SURVEY MADE FOR PROPERTY TRANSFER

PART OF THE NORTHWEST QUARTER OF SECTION 23, BUTLER TOWNSHIP T-25 N, R-17 W RICHLAND COUNTY, OHIO

Lot Split Application

HEALTH DEPT MAP

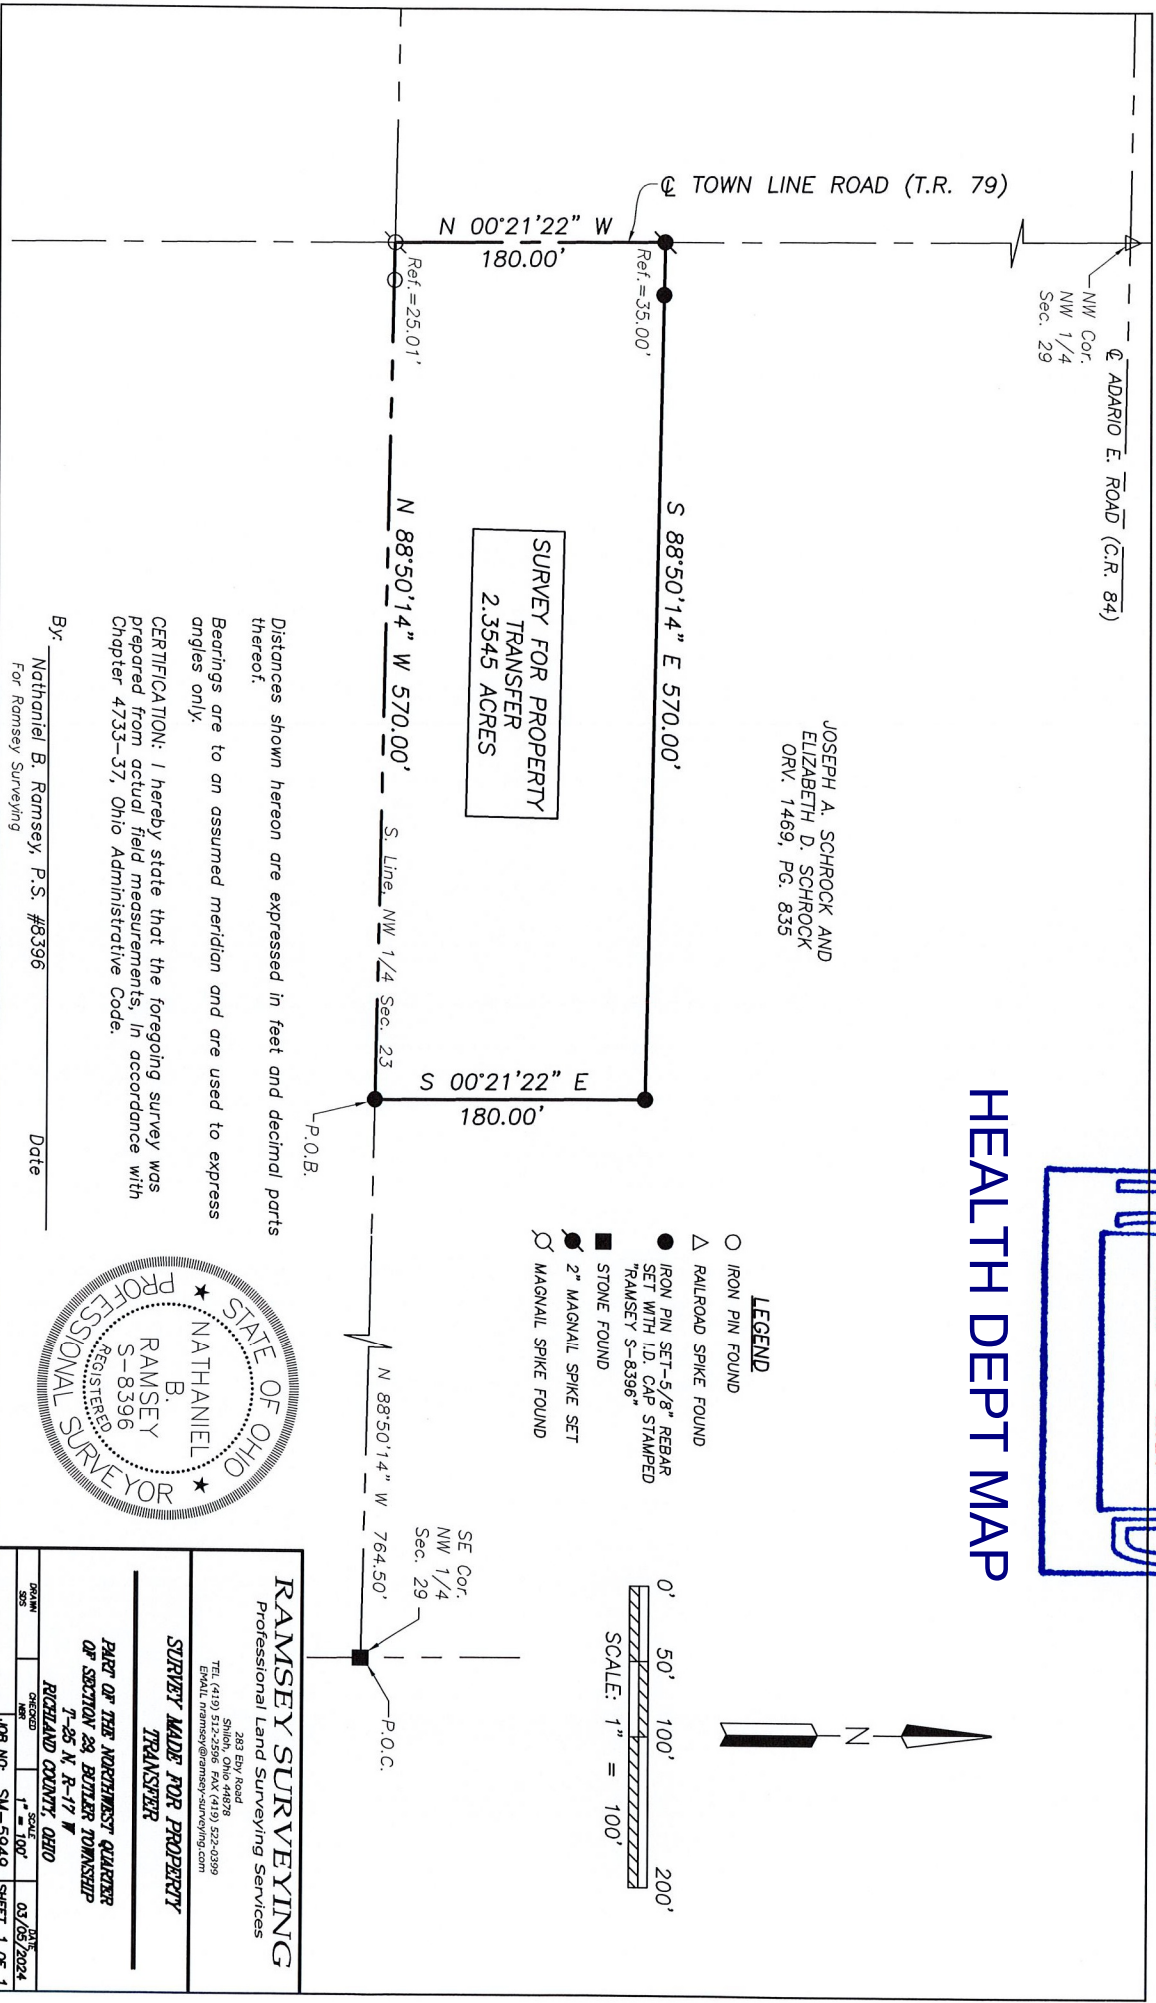
- AREAS DESIGNATED FOR INSTALLATION AND/OR REPLACEMENT OF A SEWAGE TREATMENT SYSTEM SHALL BE UNDISTURBED AND PROTECTED FROM DAMAGE OR DISTURBANCE. OAC 3701-29-15 (P)(1)
- INFORMATION PROVIDED WITH THE LOT SPLIT APPLICATION DID NOT INDICATE ANY POTENTIAL OR EXISTING EASEMENTS.
